**APPLICATION FOR PERMISSION  
UNDER SECTION 16 OF  
THE TOWN PLANNING ORDINANCE  
(CAP.131)**

For Official Use Only 請勿填寫此欄	Application No. 申請編號	A/NE-MUP/196
	Date Received 收到日期	29 AUG 2023

Application No. 申請編號	(For Official Use Only) (請勿填寫此欄)
Location/address 位置/地址	Lots 231 RP (Part), 232, 278 S.A and 278 S.B in D.D. 38, Wo Hang, Sha Tau Kok, New Territories
Site area 地盤面積	6,496 sq. m 平方米 <input checked="" type="checkbox"/> About 約 (includes Government land of 包括政府土地 N/A sq. m 平方米 <input type="checkbox"/> About 約)
Plan 圖則	Approved Man Uk Pin Outline Zoning Plan No. S/NE-MUP/11
Zoning 地帶	"Agriculture" Zone
Type of Application 申請類別	<input checked="" type="checkbox"/> Temporary Use/Development in Rural Areas for a Period of 位於鄉郊地區的臨時用途/發展為期 <input checked="" type="checkbox"/> Year(s) 年 <u>3</u> <input type="checkbox"/> Month(s) 月 _____ <input type="checkbox"/> Renewal of Planning Approval for Temporary Use/Development in Rural Areas for a Period of 位於鄉郊地區臨時用途/發展的規劃許可續期為期 <input type="checkbox"/> Year(s) 年 _____ <input type="checkbox"/> Month(s) 月 _____
Applied use/ development 申請用途/發展	Proposed Temporary Warehouse (Excluding Dangerous Goods Godown) with Ancillary Facilities for a Pe

Figure 2 – Extract from Natural Terrain Landslide Inventory Map

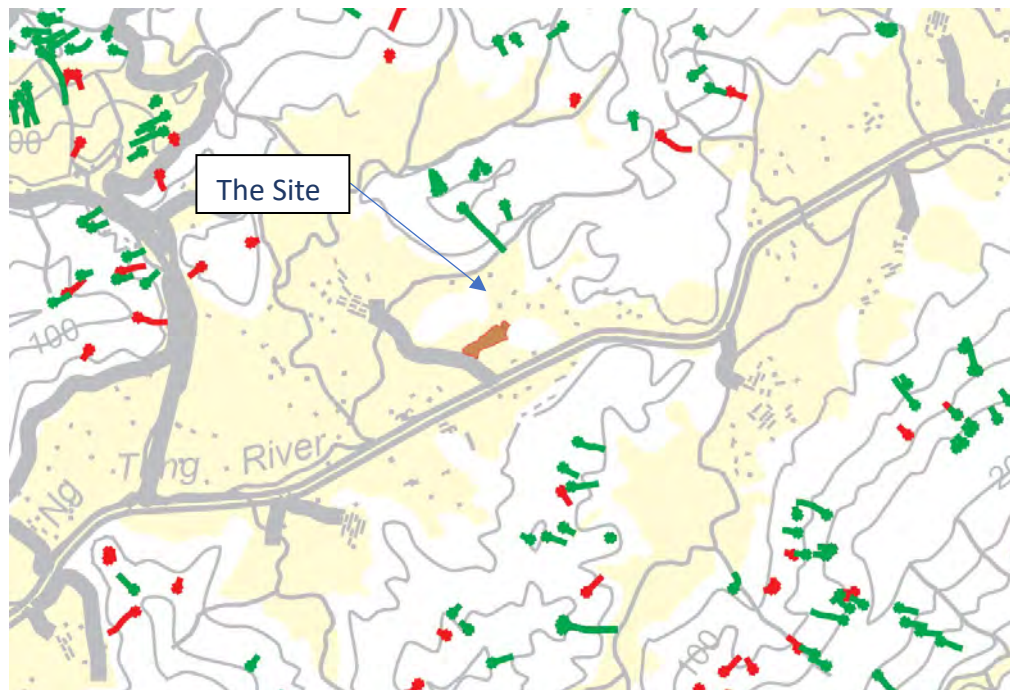
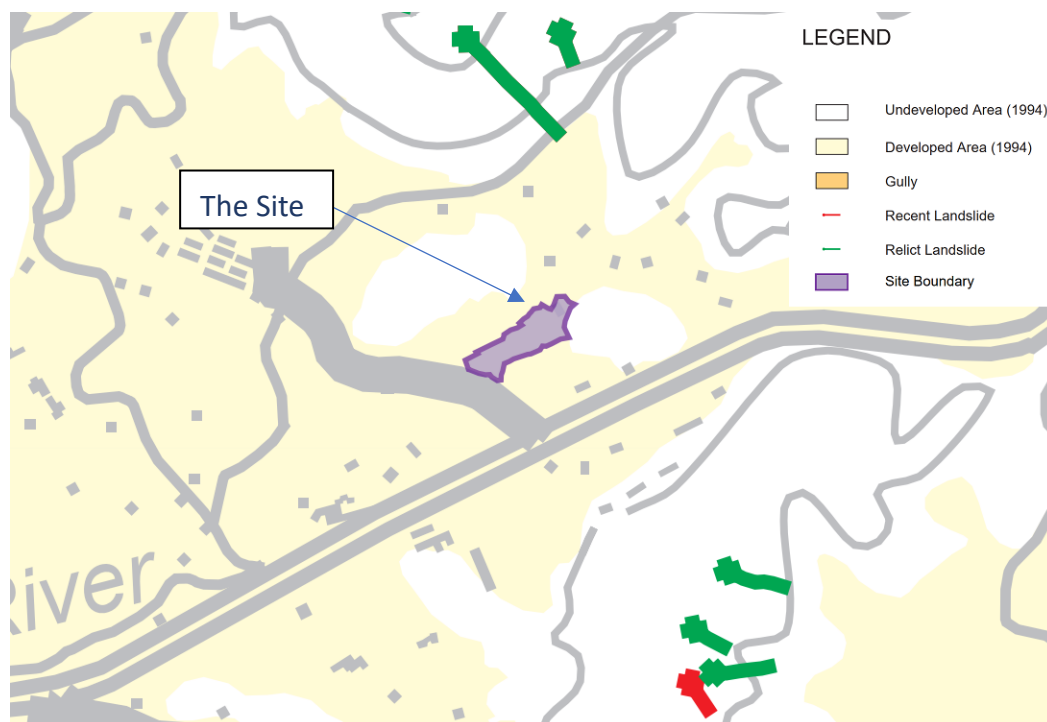
(a)	Section 4.7 Figure 2 – Please show the boundary of the application site and legends of recent and relict natural terrain landslide in the figure.	<p>Noted and revised accordingly. Details please refer to the replacement pages of the Geotechnical Planning Review Report in <b>Annex I</b>).</p> <p>Section 4.7 Figure 2 is updated to show the site boundary and legends of recent and relict natural terrain landslide.</p>
